Access Compliance Report

Public Rights-of-Way

Intersection ID: 11255	Main Street: ATTABERRY_DR	Cross Street: MATHESON_DR	Location: S
ADA ID: 687D3B28467A	Ramp Type: BlendTrans2	Initial Pass/Fail: Pass	Overall Compliance: No
Severity Score: 2.5			
Codes/Mitigation Info/Possible Solution		Field Measurements/Component Compliance

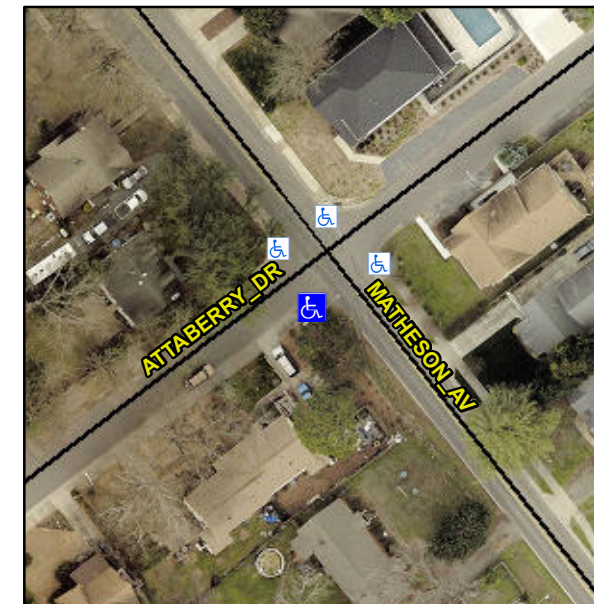
Remove & Replace Curb Ramp With Two New Directional Ramps or Equivalent. Remove & Replace Gutter.

DWS COVERING CURB & GTR

R304.2.3, R305.1.4, R302.7, R304.5.4, R304.5.3
